HD Engineering & Design

Permit No: PRRES20241195
Plan Name:
Project Address: 4359 NE HIDEAWAY DR, LEES SUMMIT, MO 64064
Parcel Number: 284206

Our firm has been asked to make structural clarifications to the plans of the house to be built at the address listed above. During the permit review process the AHJ has questioned items. Below is a list of our recommendations along with the corresponding city item.

5

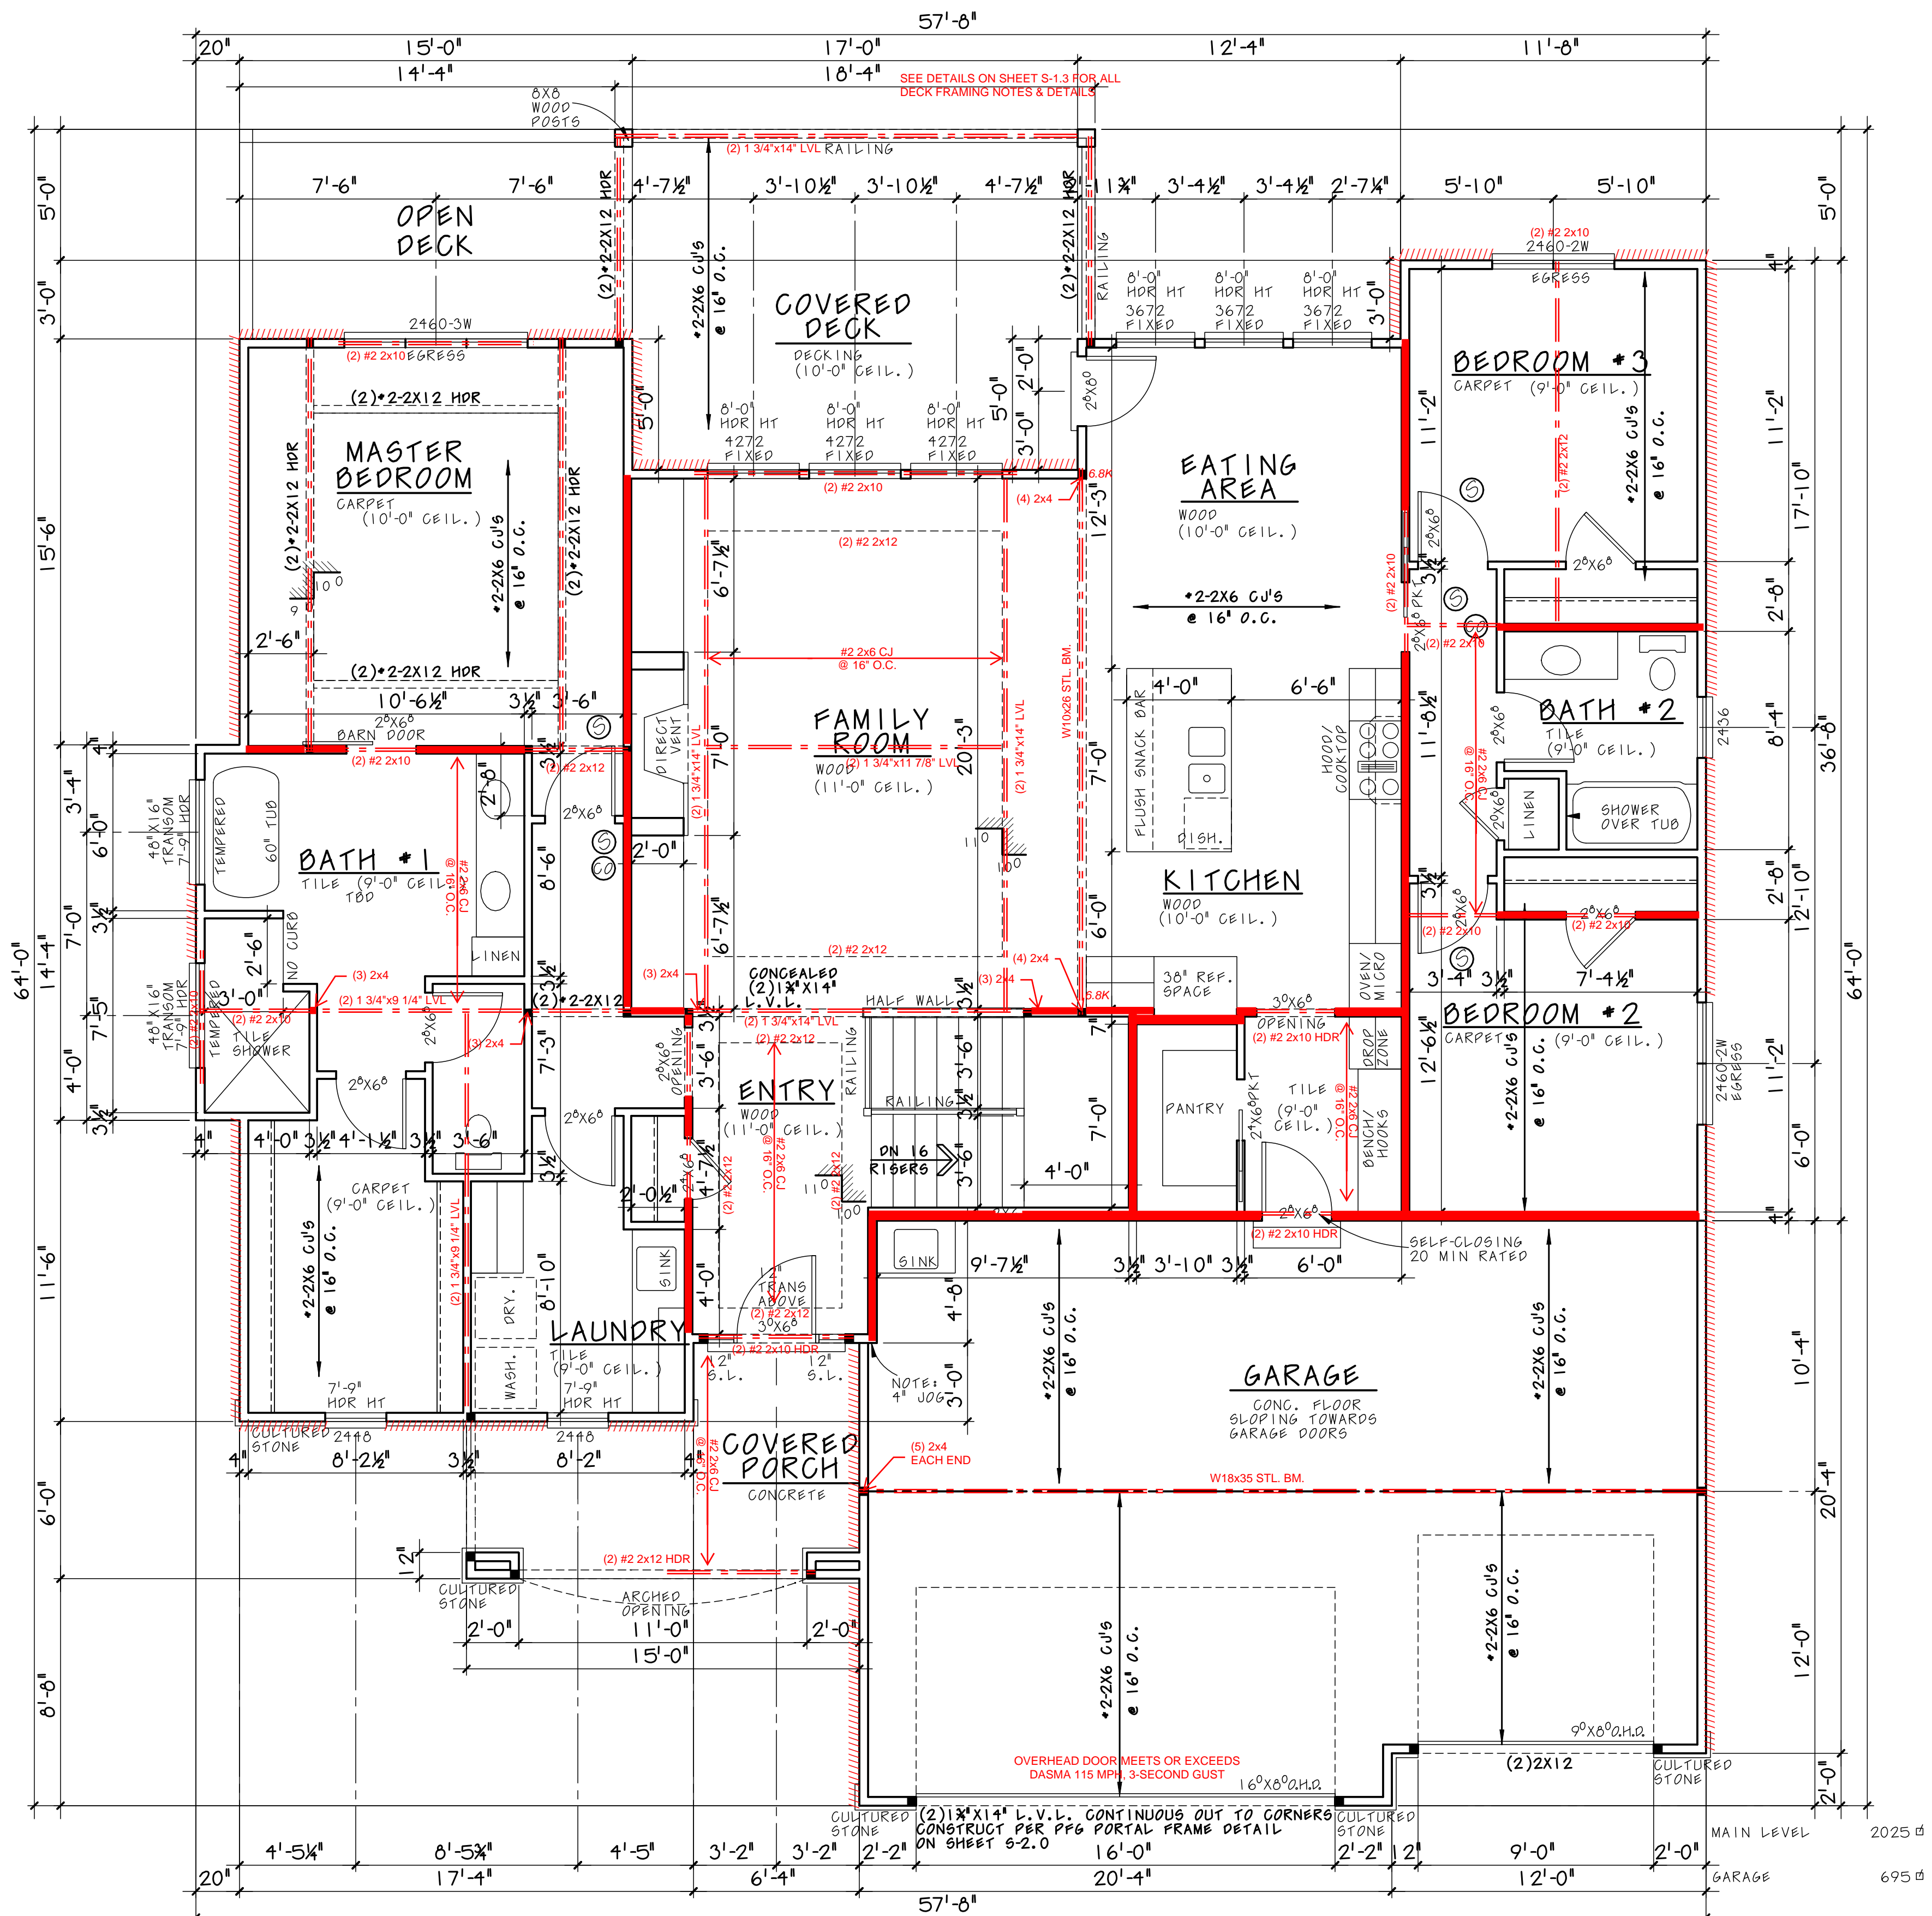
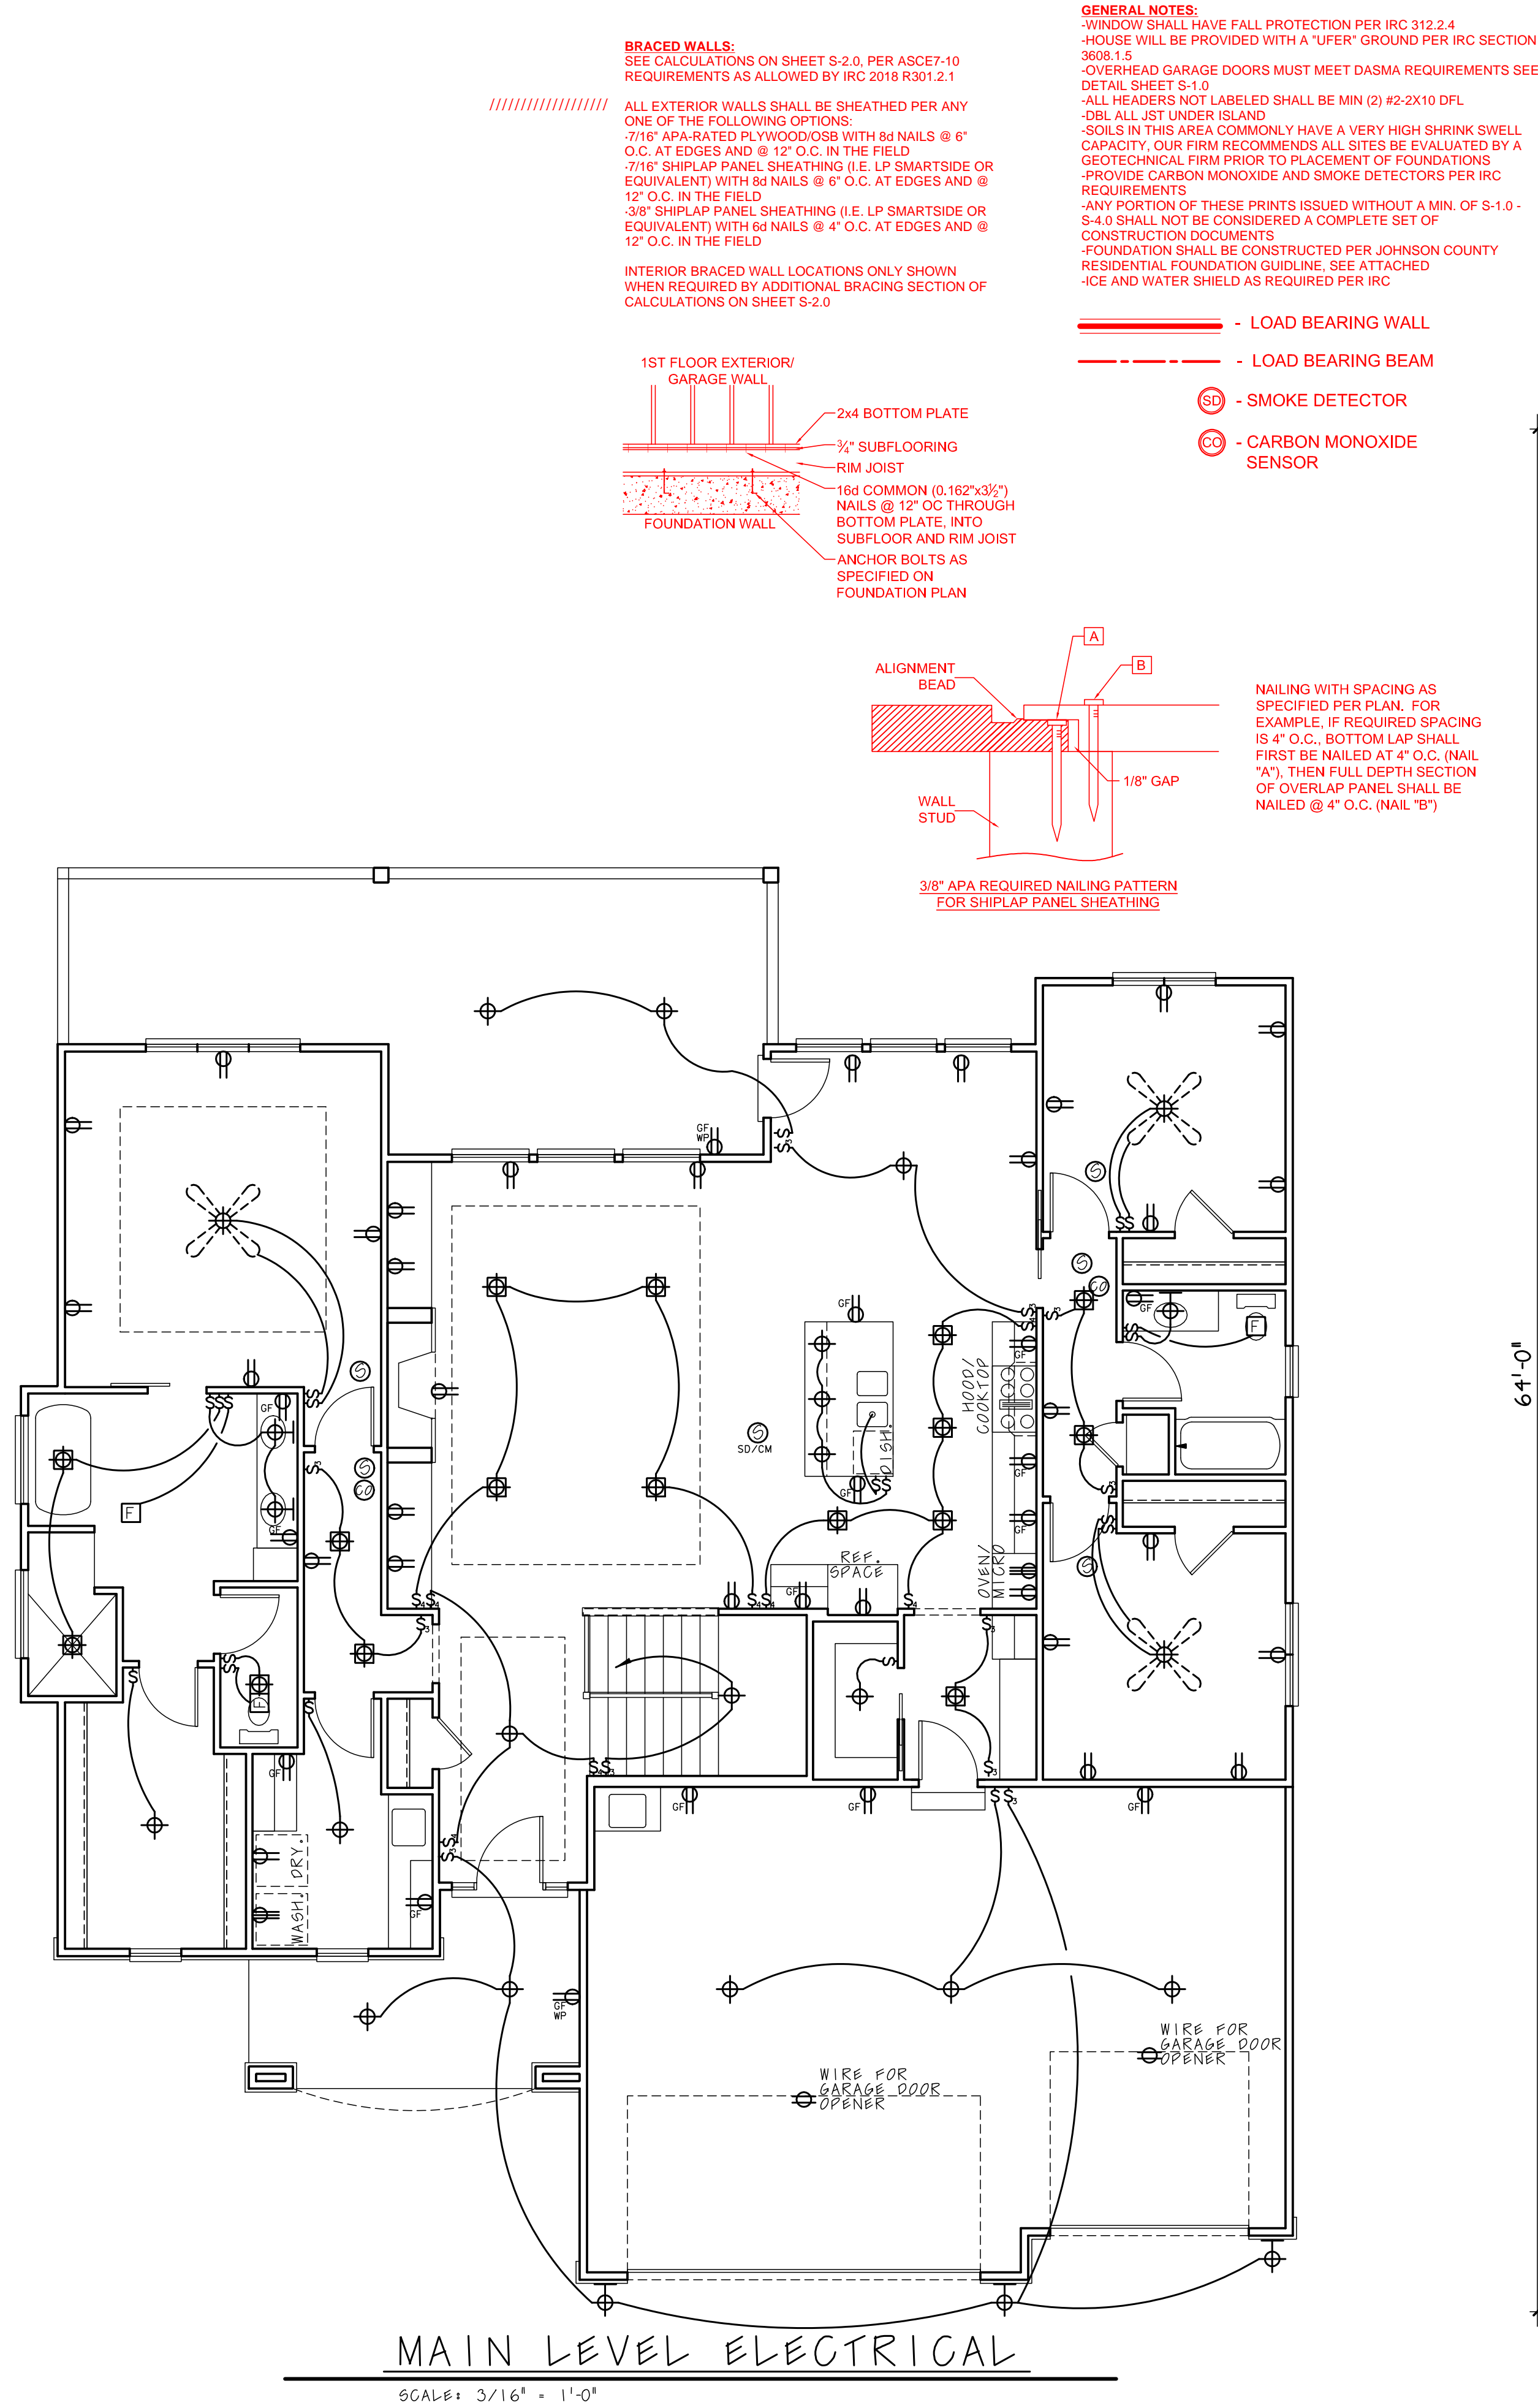
1. Provide combustion air calculations and specify transfer air grilles for fuel burning appliances located in confined space(s). (IRC Chapter 17 and Section G2407) **SEE CALCULATION ON S-1.3**
2. Footings, column pads, piers and grade beams - dimensions. (IRC Section R403) DECK PIER DETAIL NOT FOUND, SHOWS 12" DEEP PIER **SEE DETAIL AND NOTE ON SHEET 5**
3. Footings, column pads, piers and grade beams - reinforcement size and spacing. DECK PIER DETAIL NOT FOUND, SHOWS 12" DEEP PIER **SEE DETAIL AND NOTE ON SHEET 5**

03/20/2024 CITY COMMENTS
05/07/2024 PIER CHANGE
